Remarks

The present amendment responds to the Official Action dated September 20, 2004. A petition for a one month extension of time to respond and authorization to charge Deposit Account No. 50-1058 the large entity extension fee of \$120 accompany this amendment. The Official Action objected to informalities in claims 1-22. The Official Action rejected claims 1-22 under 35 U.S.C. 112, second paragraph. The Official Action also rejected claims 1-3, 11-14 and 20-22 under 35 U.S.C. §103(a) based on Womack et al. U.S. Patent No. 5,982,819 (Womack) in view of Ivo et al. "DSP and Digital Down Conversion" Proceedings of the Radioelektronika 99, pp. 225-228 (Ivo). The Official Action rejected claims 4-6 and 15-17 under 35 U.S.C. §103(a) based on Womack in view of Ivo and further in view of Thacker U.S. Patent No. 6,011,548 (Thacker). The Official Action also rejected claims 7-10 and 18-19 under 35 U.S.C. §103(a) based on Womack in view of Ivo and further in view of Tourtier U.S. Patent No. 5,446,495 (Tourtier). These grounds of rejection are addressed below. Claims 1-9 and 11-22 have been amended to be more clear and distinct and new claims 23 and 24 have been added. Claims 1-24 are pre

FIGURE 1

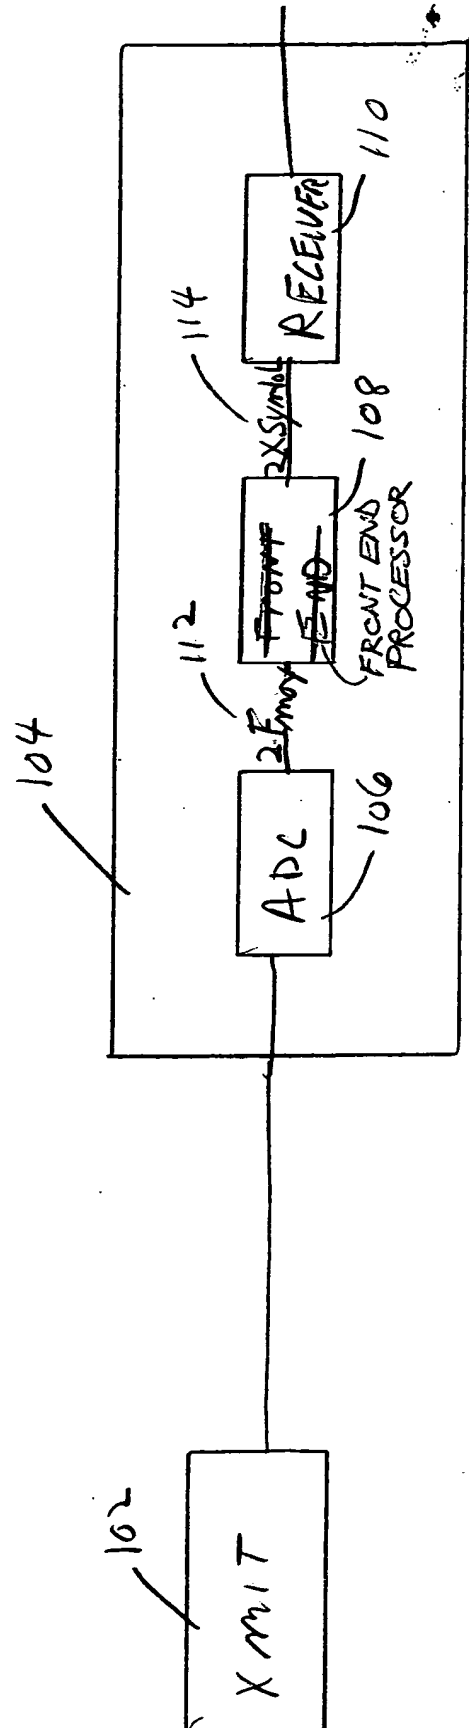
The paragraph beginning on page 7, line 11 has been amended to correct an incomplete sentence so as to properly reference the two main elements of Figure 1. The sentence beginning on line 15 "In an illustrative embodiment, the system 100 a transmitter 102 and a receiver system 104." is amended to "In an illustrative embodiment, the system 100 includes a transmitter 102 and a receiver system 104."

FIGURE 3

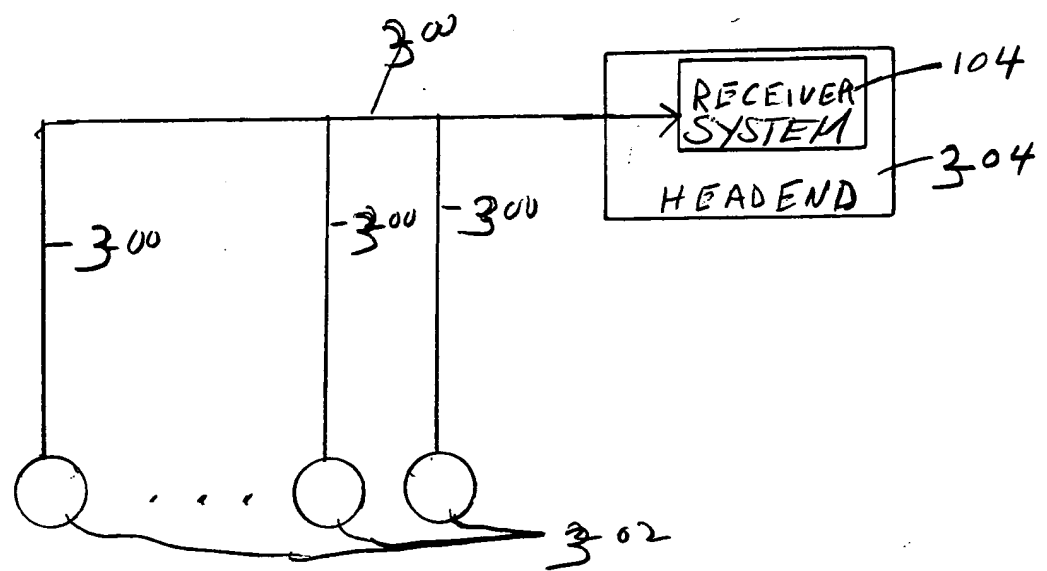
The paragraph beginning on page 9, line 1 has been amended to correct a reference to the system illustrated in Figure 3. The communications system 100 of Figure 1 illustrates a system having a single transmitter 102. In the paragraph beginning on page 9, line 1 reference to system 100 has been amended to reference system 310 consistent with the discussion in the same sentence which addresses a system having multiple transmitters. The system 310 reference is also added to line 10.

FIGURE 6

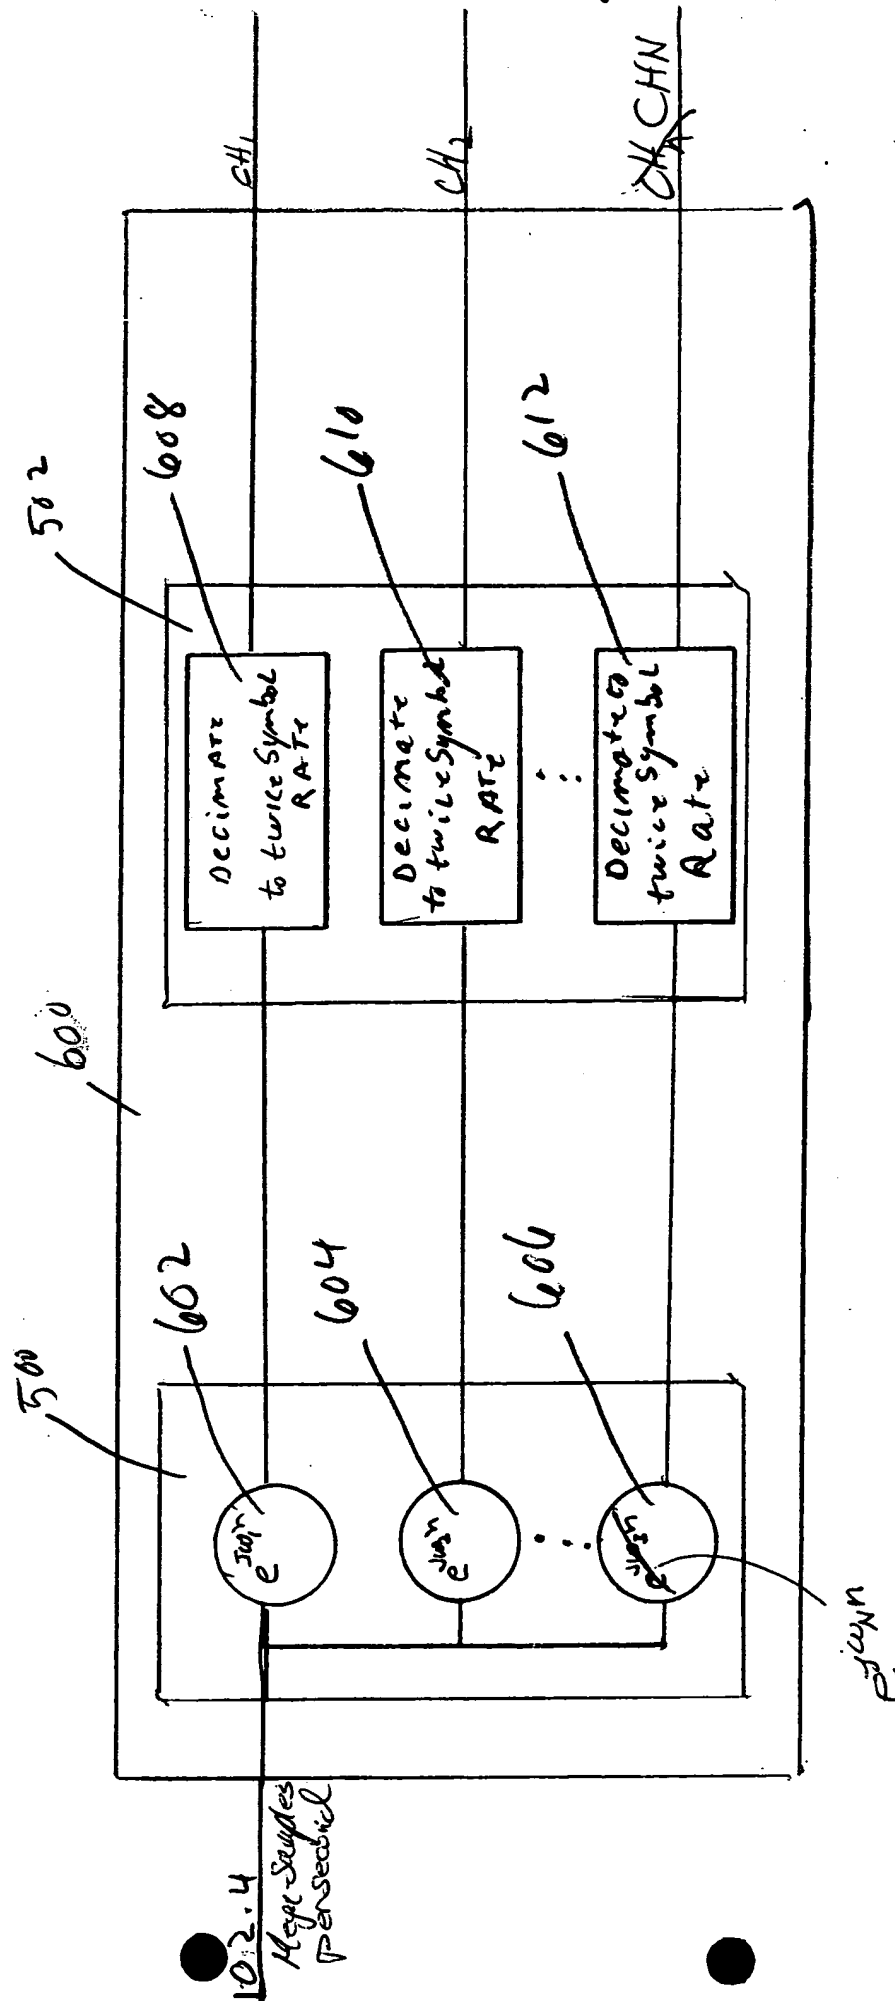
The paragraph beginning on page 11, line 13 has been amended to correct the name of element 600 in Figure 6 from a front end 600 to a front end processor 600. Support for this change can be found in the brief description of the drawings for Figure 6 which states that "Figure 6 is a conceptual block diagram of one embodiment of a front end processor in accordance with the present invention". Further support for this change can be found in the second sentence of this paragraph that begins "The front end processor 600..." and correctly identifies element 600 as a front end processor. Also, the paragraph has been amended to clarify the usage of 102.4 in line 21 to be 102.4 mega-samples per second. Support for this change can be found in the first sentence of this paragraph on page 11, beginning on line 13 where the sample rate of 102.4 mega-samples per second was introduced.

The paragraph beginning on page 12, line 1 has been amended to change the reference name for element 600 from a front end 600 to a front end processor 600 in the first three sentences of this paragraph. The mathematical term on line 11 $e^{j\omega_N n}$ is changed to $e^{j\omega_N n}$ to correct a typo consistent with the usage of the mathematical term in the same sentence defining ω_N , "where ω_N is the center frequency". This same sentence is further amended to remove a

The paragraph beginning on page 14, line 14 has been amended at lines 16 and 17 to change "the front end described in the discussion related to Figure 6" to "the front end processor described in the discussion related to Figure 6" to correctly reference the front end processor in Figure 6 that is discussed on page 11, lines 16-19. A typographical error is corrected in line 19 changing "Such as system" to "Such a system". The reference numbers to the down-converters in Figure 7 have been amended in line 28 changing "converters 728 through 726" to "converters 702 through 726". Support for this change can be found in the preceding paragraph beginning on page 14, line 5 where the down-converters in Figure 7 were introduced.

FIGURE 12

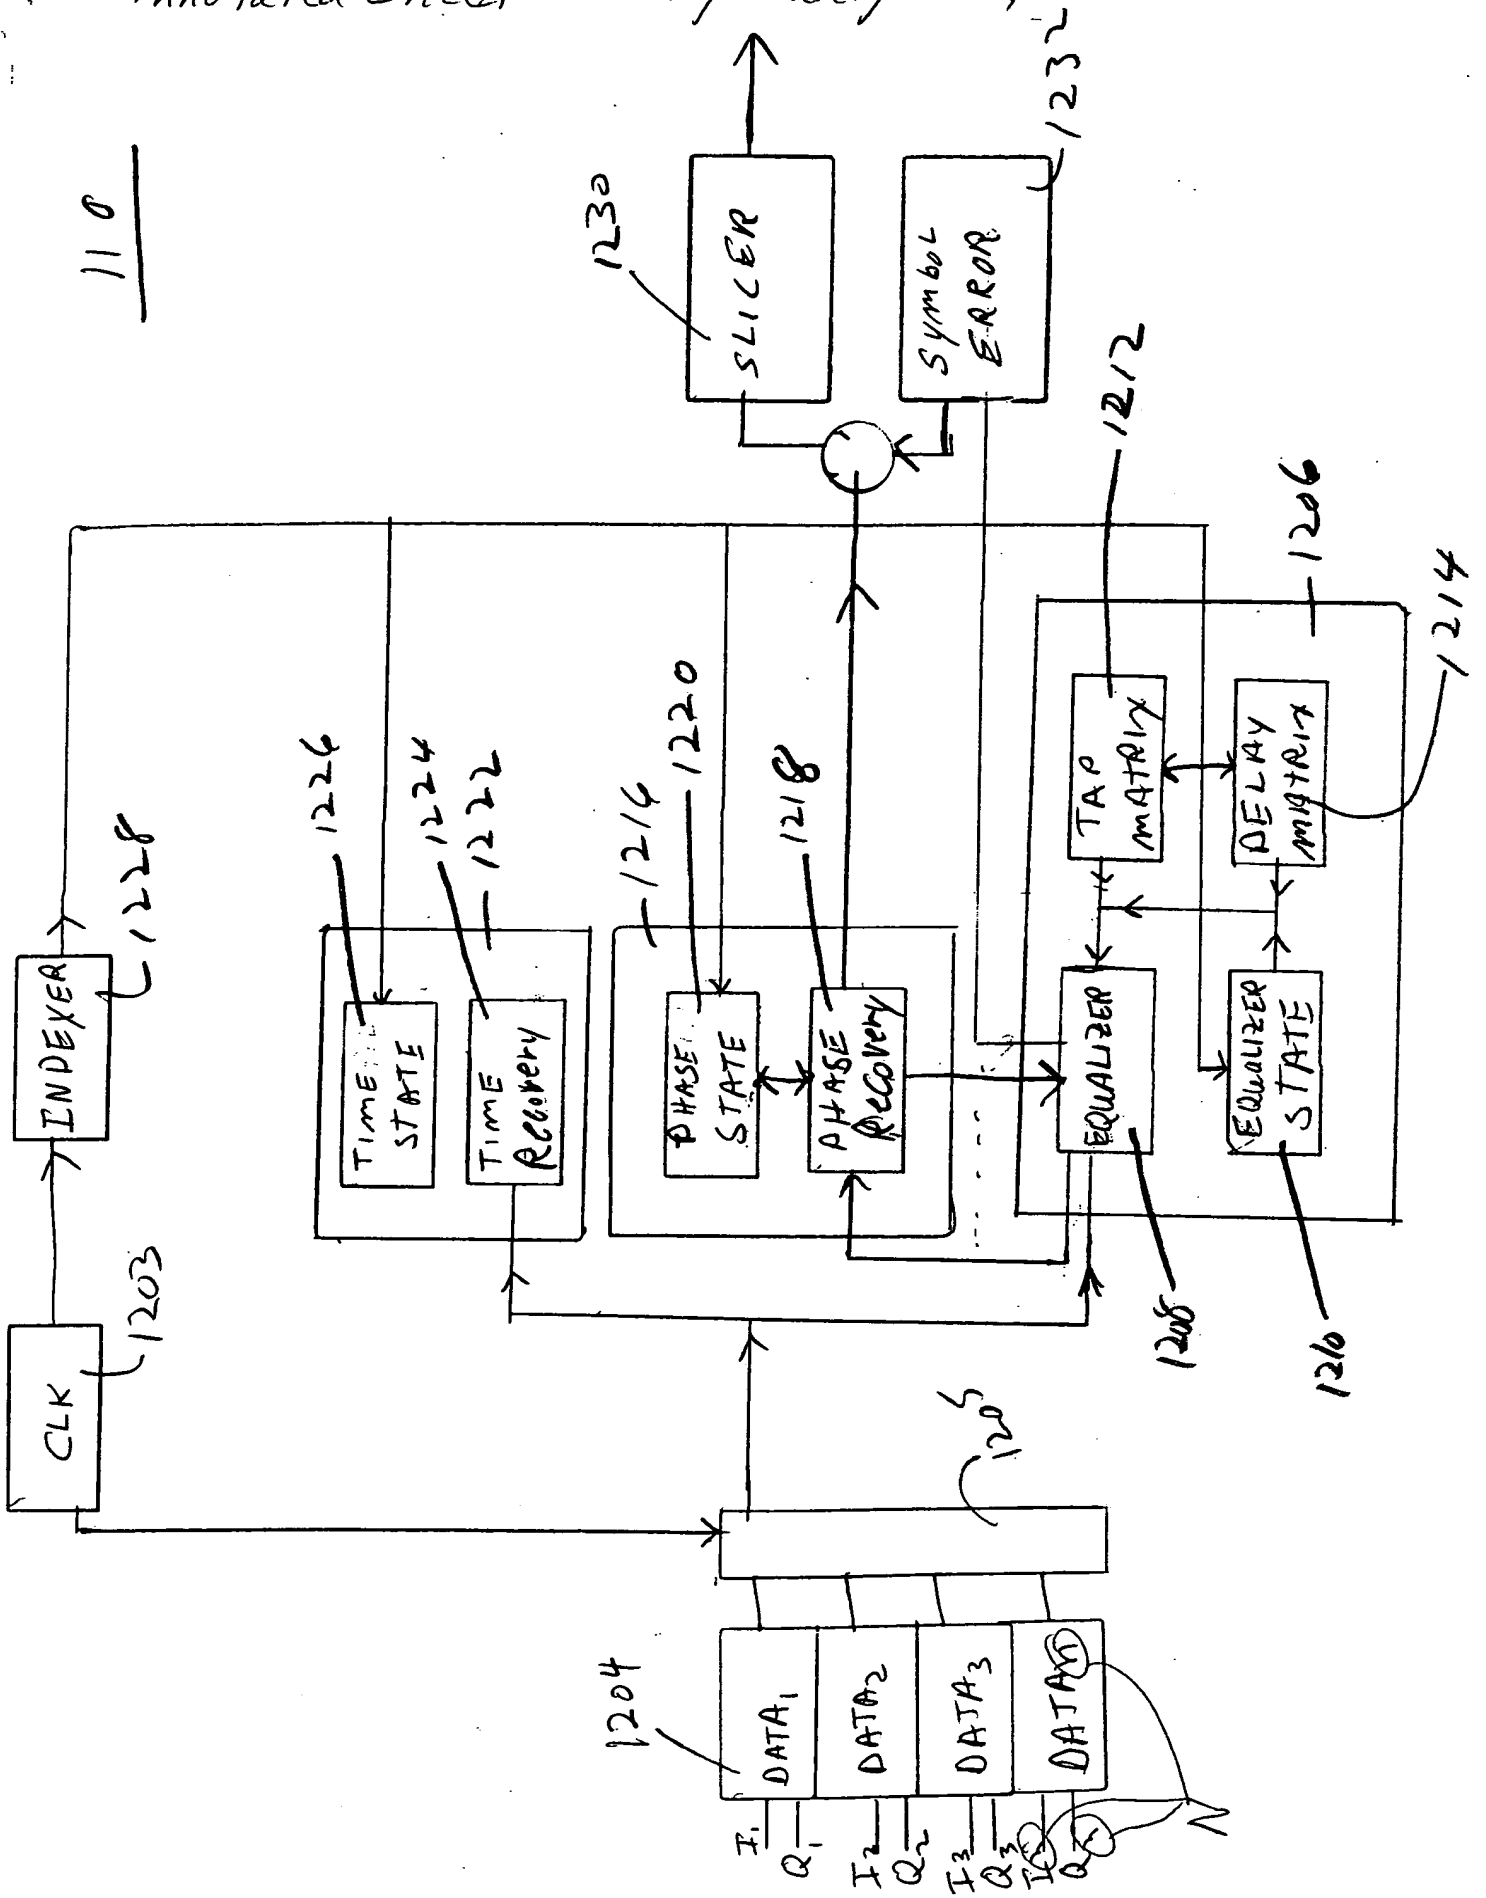
The paragraph beginning on page 19, line 8 has been amended in line 13 to change "A clock 1206" to "A clock 1203" to be consistent with the numbering of the clock, abbreviated as CLK 1203, used in Figure 12.

The paragraph beginning on page 19, line 23 has been amended to clarify the description of the elements 1218, 1220, 1224, and 1226 used in Figure 12. The short operational titles used for elements 1218, 1220, 1224, and 1226 in Figure 12 are included in parenthesis in the description of the elements. The "phase tracking loop 1218" is changed to "phase tracking loop (phase recovery) 1218" and the "phase tracking storage 1220" is changed to "phase tracking storage (phase state) 1220". Also, the "time tracking loop 1224" is changed to "time tracking loop (time recovery) 1224" and the "time tracking storage 1226" is changed to "time tracking storage (time state) 1226".

The paragraph beginning on page 21, line 14 has been amended to correct the name of element 1206 in Figure 12 in lines 15 and 17 from "equalizer 1206" to "equalizer subsystem 1206". Support for this change can be found in the paragraph beginning on page 19, line 8 where the "equalizer subsystem 1206" is introduced at line 16.

The paragraph beginning on page 23, line 26 has been amended to correct two incorrect reference numbers and a typo. The "equalizer 1204" on page 24, line 1 has been amended to "equalizer 1208" to properly reference the equalizer 1208 in Figure 12. The "equaiizer 1208" has been amended to "equalizer 1208" to correct the misspelling. The "state vector 1226" has been amended to "state vector 1220" to properly reference the updated phase tracking loop state vector that is stored in the phase tracking storage (phase state) 1220.

FIGURE 13

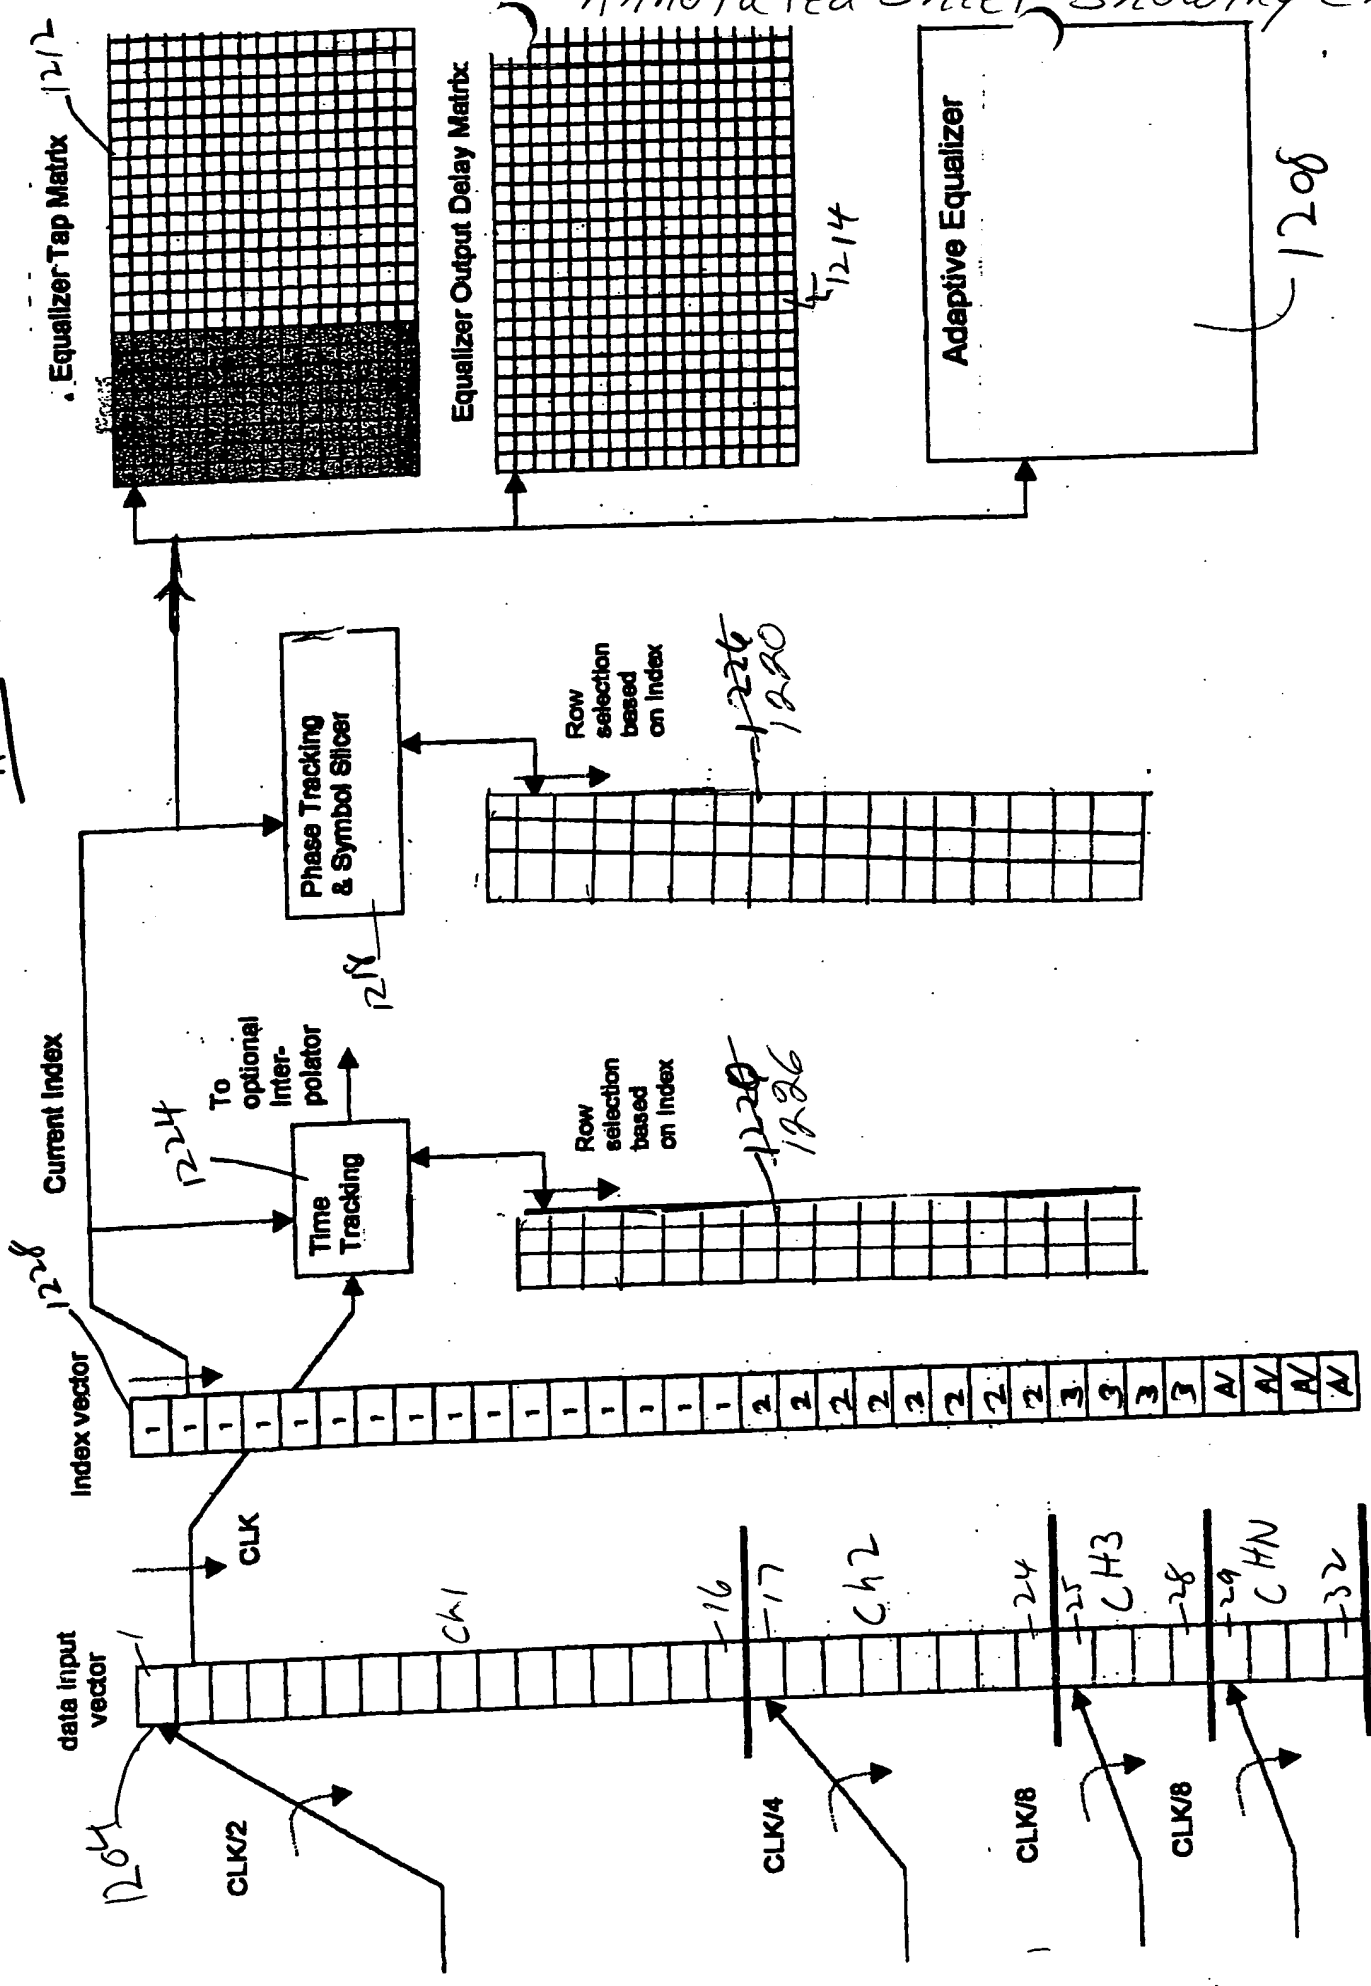
The paragraph beginning on page 21, line 27 has been amended to correct the reference of channel n to channel N as used in Figure 13 in data memory 1204 and generally in the specification for the Nth channel. In line 28 of this paragraph, "channels 1 through "n" respectively" has been amended to "channels 1 through "N" respectively". On page 22, lines 6 and 8 of this paragraph, "three and n" has been amended to "three and N". Support for this change can be found in the paragraph beginning on page 20, line 27 where on page 21 channel N is discussed at lines 7-10.

The paragraph beginning on page 22, line 27 has been amended to change the reference to CH4 to CHN as illustrated in Figure 13 in the context of the discussion on channels 1, 2, 3, and N. For example, in this paragraph on page 23, beginning at line 1, the thirty-two locations of data memory 1204 in Figure 13 are described where "the first sixteen of which are allocated to

The paragraph beginning on page 23, line 7 has been amended to correct an incorrect channel name and incorrect reference numbers. In line 8 of this paragraph, CH4 has been changed to CHN to properly reference the use of CHN in Figure 13. The references to elements 1218, 1220, and 1226 has been corrected in the description to be consistent with the elements labeled 1218, 1220, and 1226 in Figure 12 and Figure 13. In lines 10 and 11, "the phase tracking loop 1226" has been changed to "the phase tracking loop (phase recovery) 1218". In line 15, "the time tracking loop vector 1220" has been changed to "the time tracking loop vector 1226". In line 18, "the phase tracking loop vector 1226" has been changed to "the phase tracking loop vector 1220" and in line 23, "phase tracking loop state vector 1226" has been changed to "phase tracking loop state vector 1220".
